FED. ROAD DIST. NO.	STATE	FED. AID PROJ. NO.	FISCAL YEAR	SHEET NO.	TOTAL SHEETS
HAWAII	HAW.	BR-STP-056-1(35)	2000	C.O. 17	70

WAIKAEA BRIDGE WIDENING

KUHIO HIGHWAY-WAIKAEA BRIDGE WIDENING
Fed. Aid Proj. No. BR-STP-056-1(35)

SHEET No. S20 OF 26 SHEETS

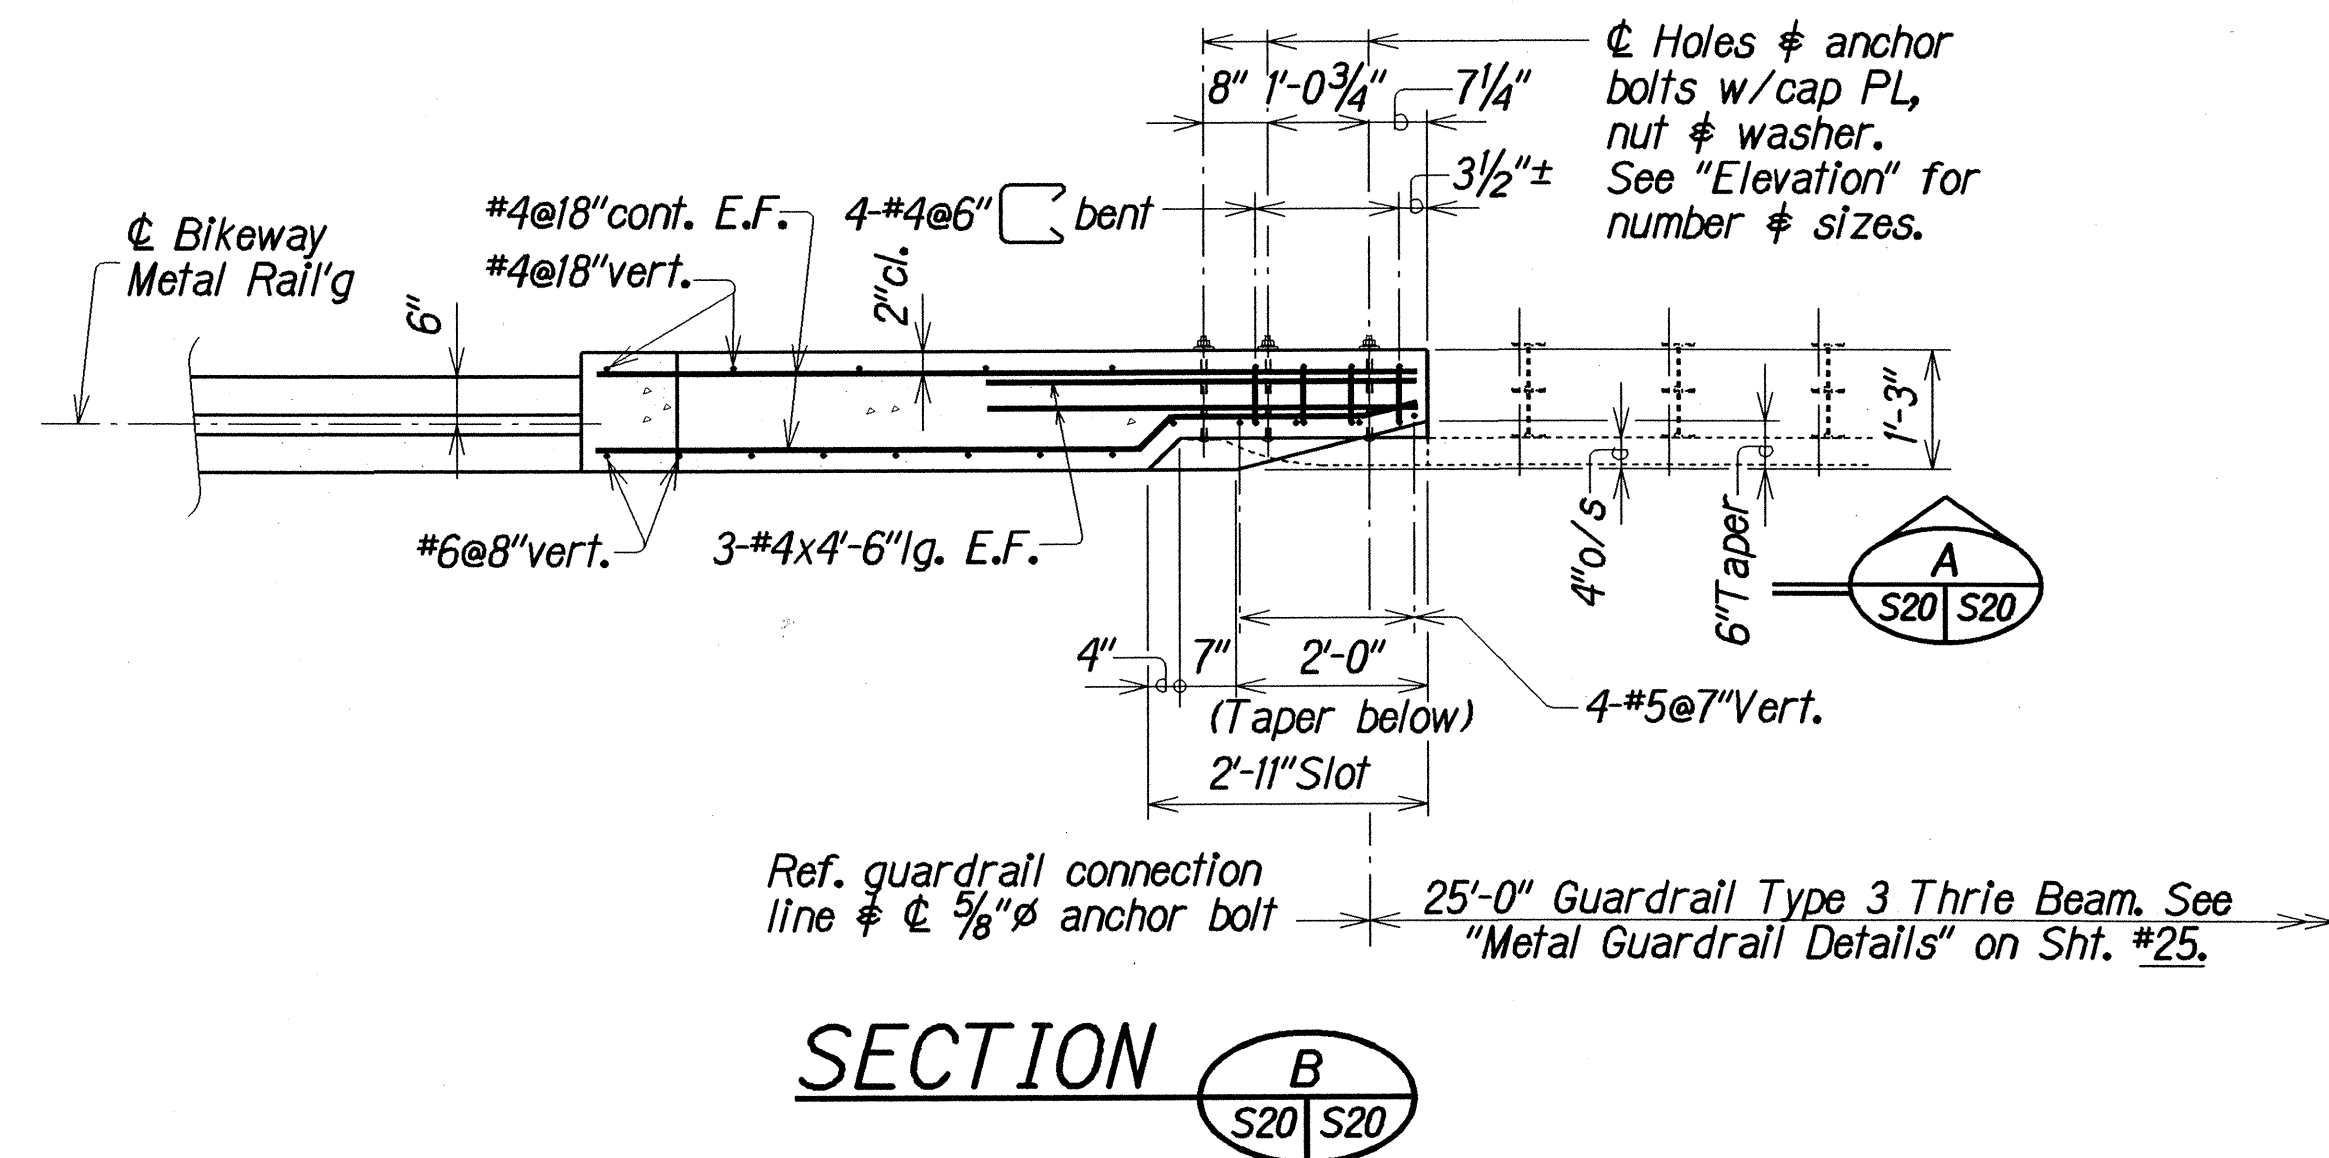
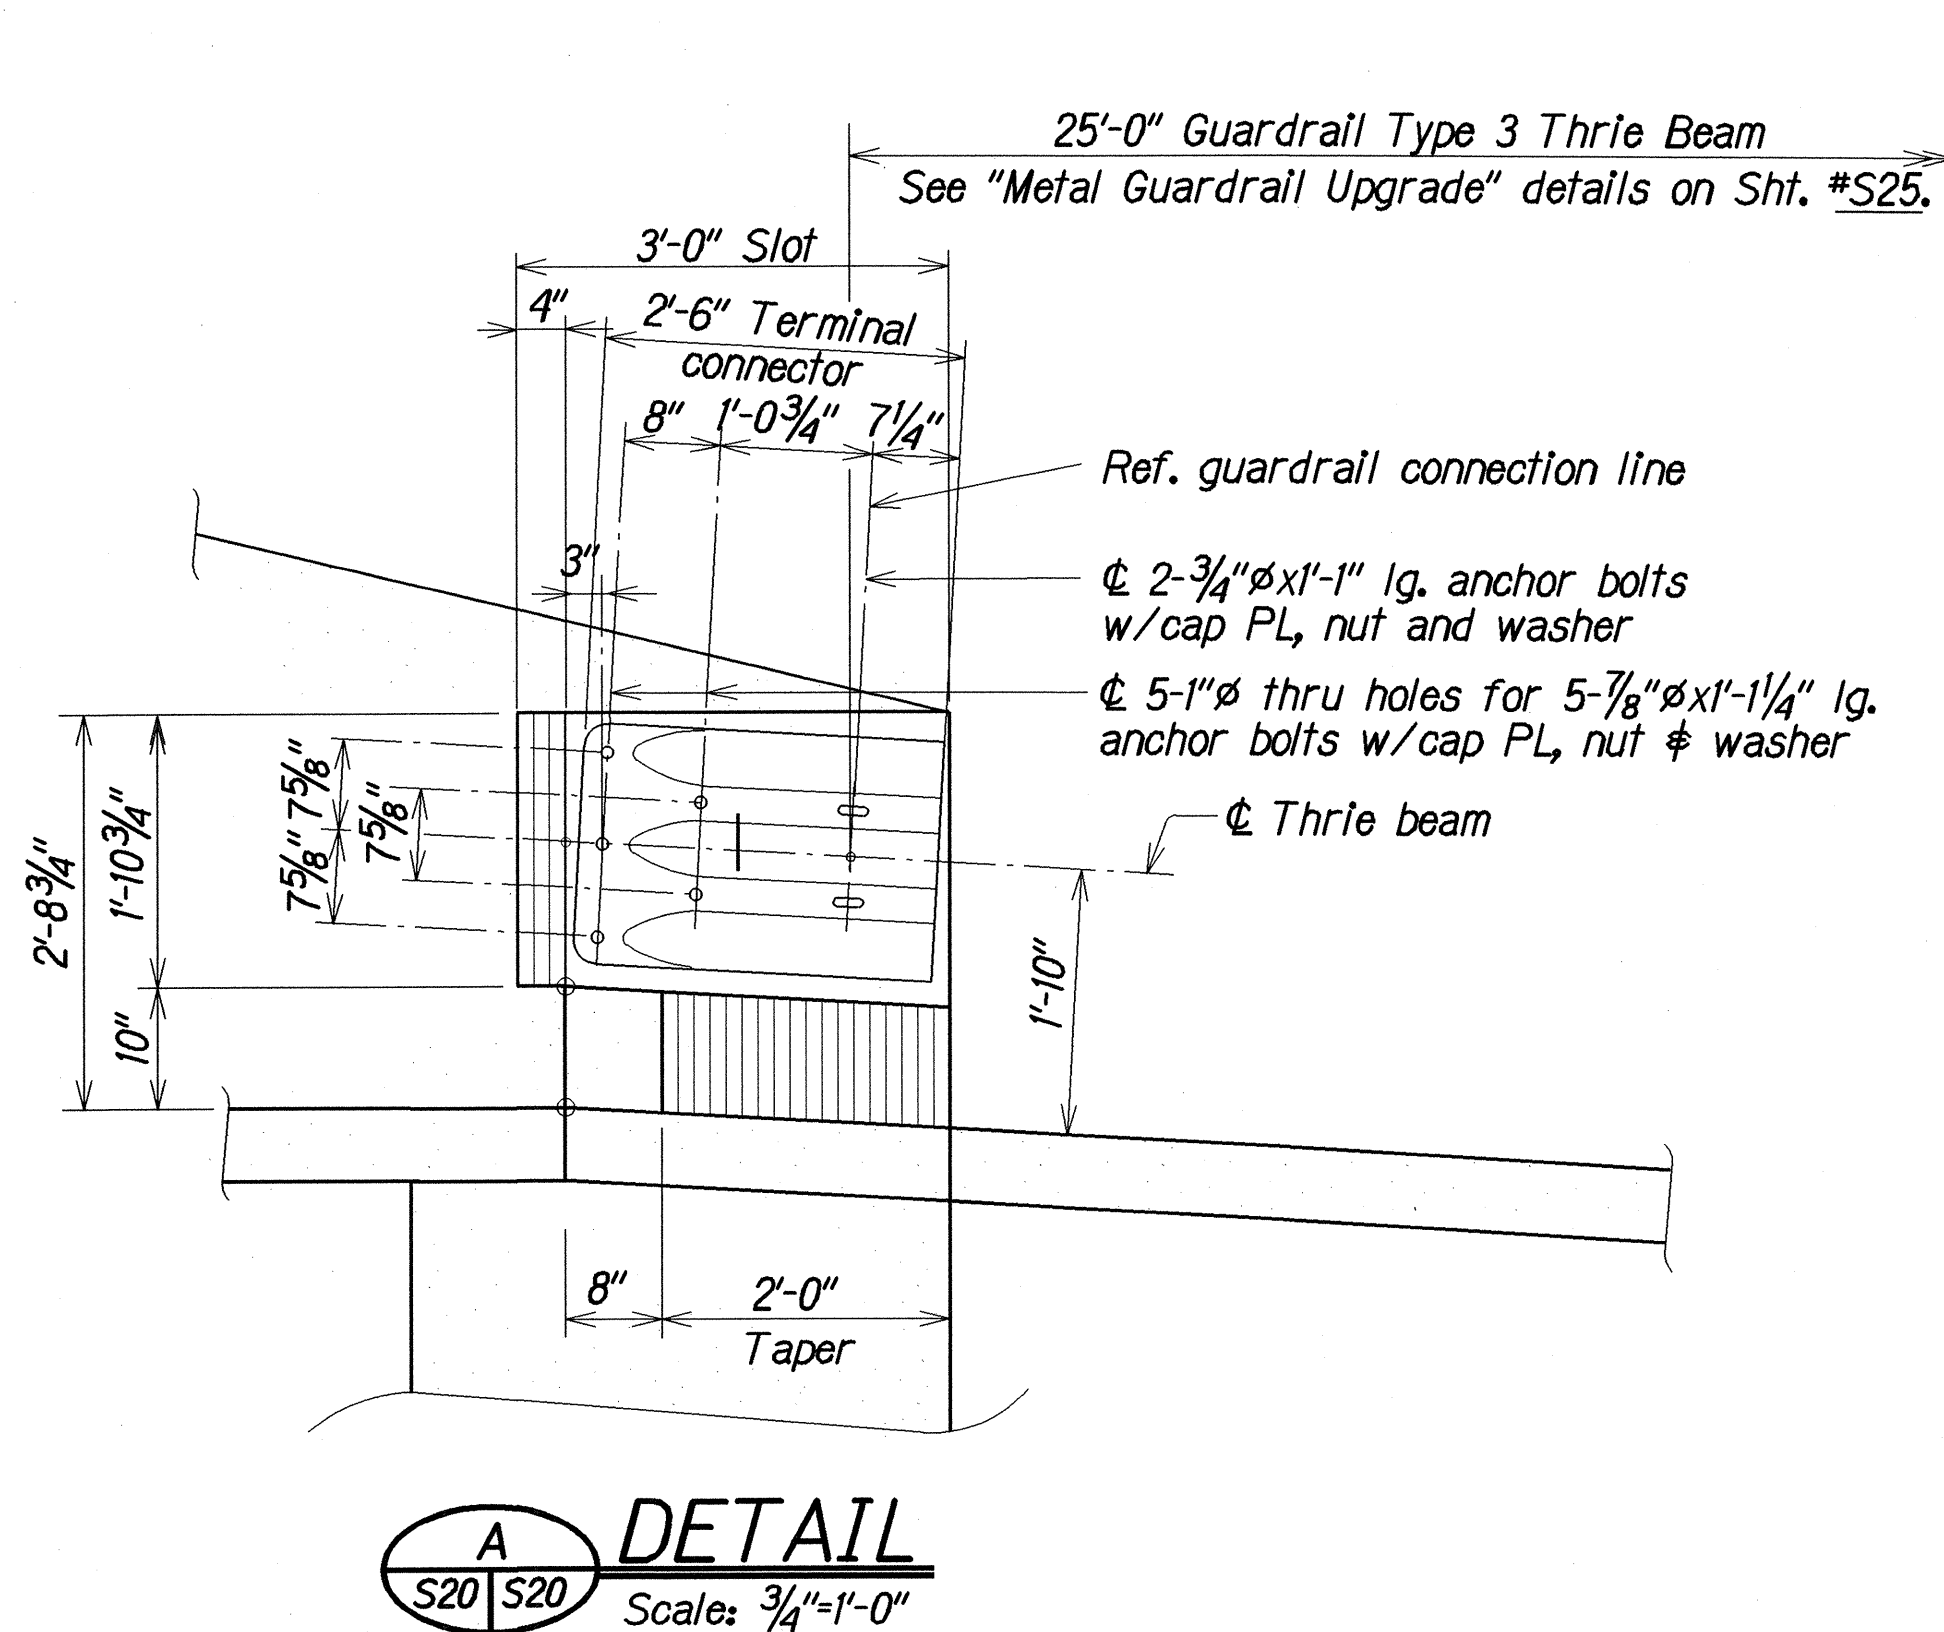
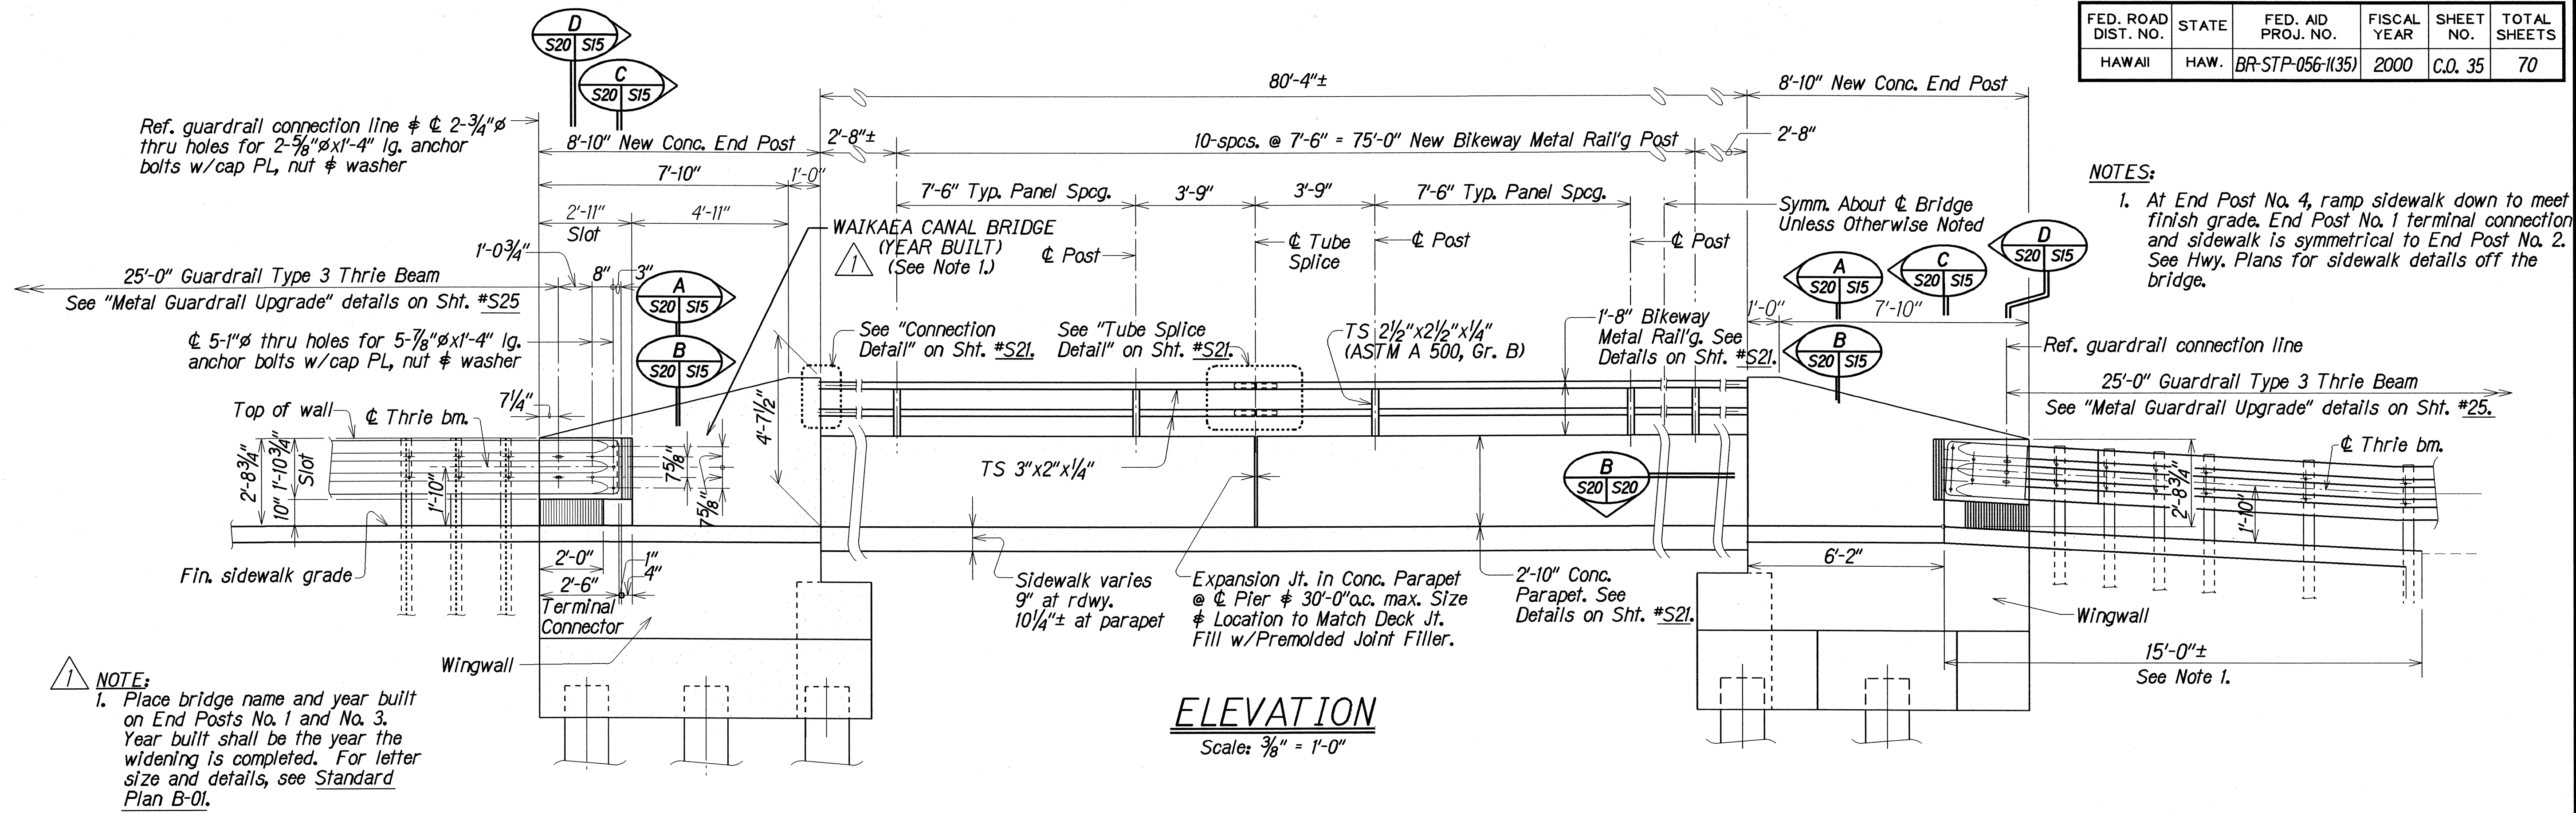
1/29/02	Added bridge name and year built on End Posts No. 1 and No. 3.
DATE	REVISION
STATE OF HAWAII DEPARTMENT OF TRANSPORTATION HIGHWAYS DIVISION	
WAIKAEA BRIDGE WIDENING	
CONCRETE RAILING, METAL GUARDRAIL AND BIKEWAY METAL RAILING	
KUHIO HIGHWAY-WAIKAEA BRIDGE WIDENING	
Fed. Aid Proj. No. BR-STP-056-1(35)	
Scale: As Noted	Date: Aug. 1999
